**UNITED STATES
NUCLEAR REGULATORY COMMISSION
REGION IV
611 RYAN PLAZA DRIVE, SUITE 400
ARLINGTON, TEXAS 76011-4005**

**SUBJECT: SOUTH TEXAS PROJECT ELECTRIC GENERATING STATION - NRC SPECIAL
INSPECTION TEAM REPORT 05000498/2003008 AND 05000499/2003008 AND
EXERCISE OF ENFORCEMENT DISCRETION**

Report No: 05000498/2003008
05000499/2003008

Facility: South Texas Project Electric Generating Station, Units 1 and 2

Figure 2

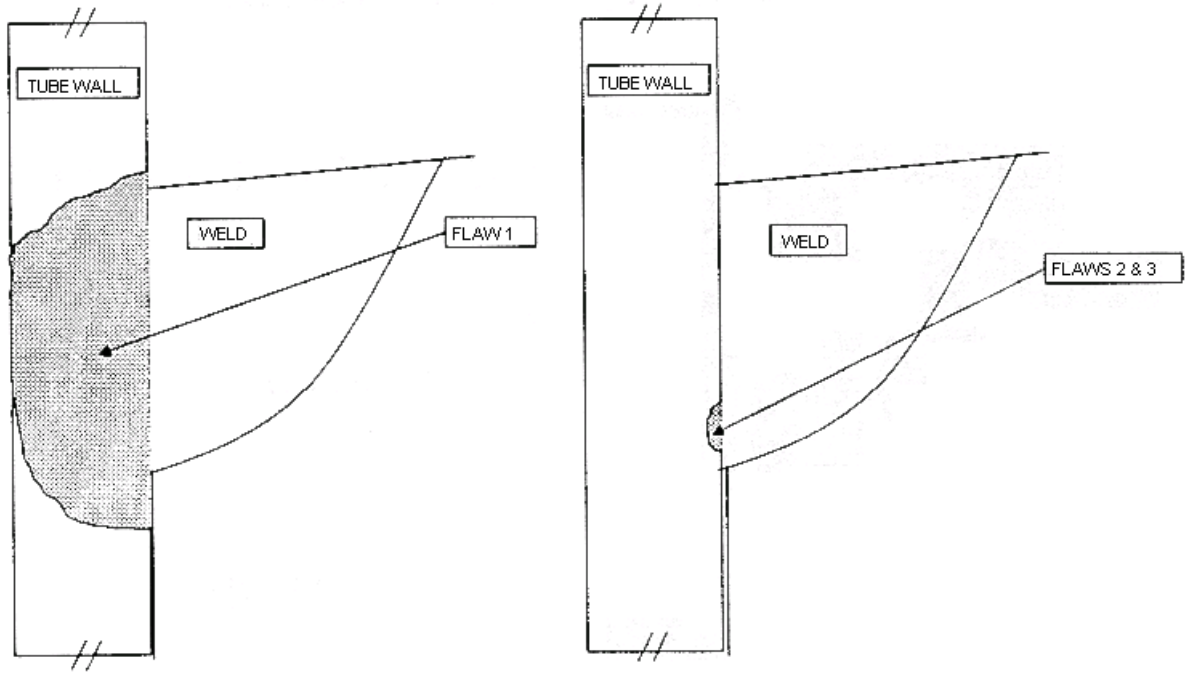
The results from BMI Penetration 1 are depicted in Figure 2. Three axially-oriented crack-like indications were identified in the nozzle wall. One of the indications was characterized as an axial crack with a length of about 1.38 inches, surface breaking on the OD of the nozzle above and below the J-groove weld, as well as surface breaking on the ID of the nozzle. The ID surface breaking nature of this flaw was confirmed by the ET examination. The OD surface breaking nature of this flaw was confirmed by the helium gas test. The other two indications were characterized as being small, embedded (i.e., non-surface breaking) cracks near the interface between the nozzle wall and the root pass of the J-groove weld.

Figure 3

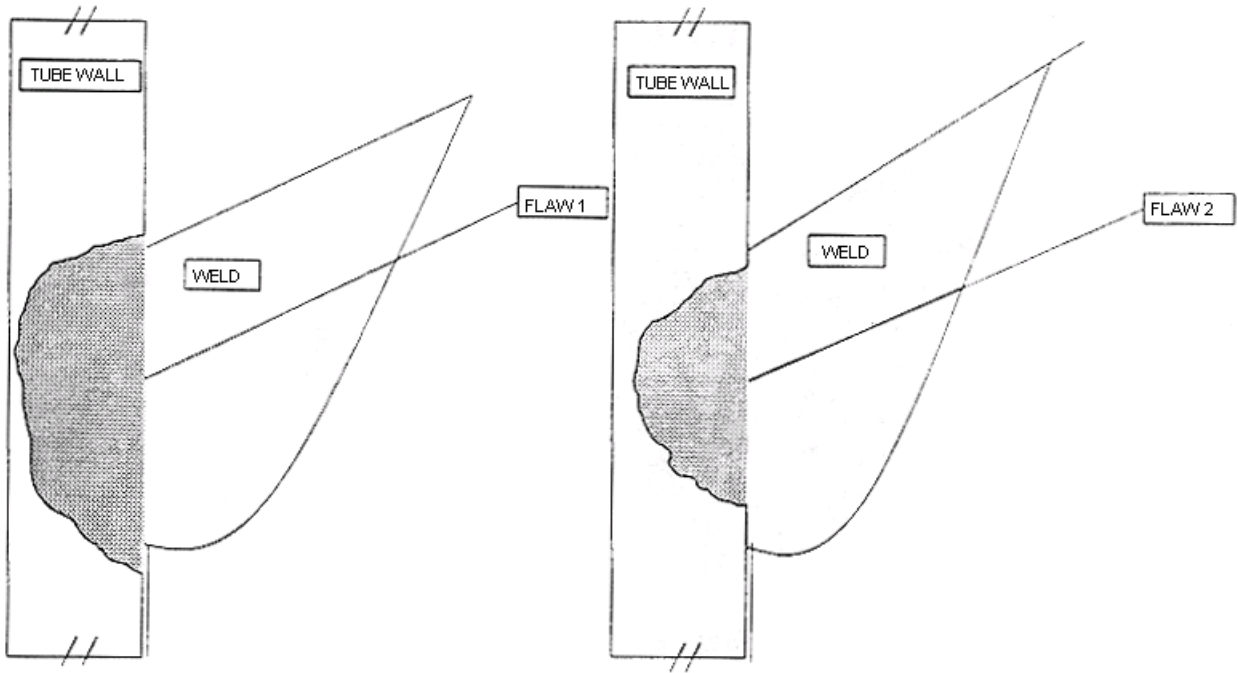
The results from BMI Penetration 46 are depicted in Figure 3. Two axially-oriented crack-like indications were identified in the nozzle wall. One of the indications was characterized as an axial crack with a length of about 0.98 inches, surface breaking on the OD of the nozzle above and below the J-groove weld. The surface breaking nature of this flaw was unable to be confirmed by the helium gas test. The flaw was not found to be surface breaking on the ID of the nozzle by the ET examination. The other indication was characterized as an embedded crack having an axial length of 0.95 inches.

Figure 4

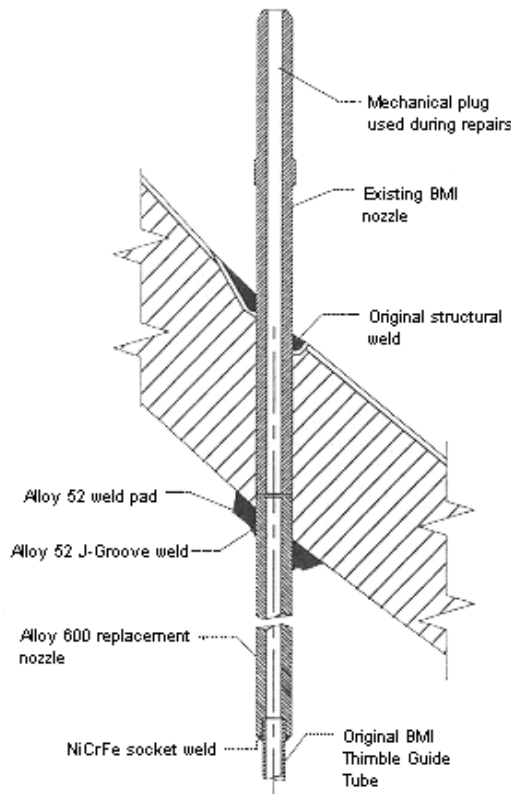
Upon the discovery of the deposits around STP, Unit 1, BMI Penetrations 1 and 46, the licensee began the process of designing a potential repair option. The licensee developed a “half-nozzle” repair which was similar in design to those which had been implemented at other facilities for the repair of cracked pressurizer heater penetrations, RCS instrumentation penetrations, etc. This repair option was chosen and characterized as a permanent repair of STP, Unit 1, BMI Penetrations 1 and 46. A cross-section of the repair design is shown in Figure 4. The essential elements of the repair design were as follows:
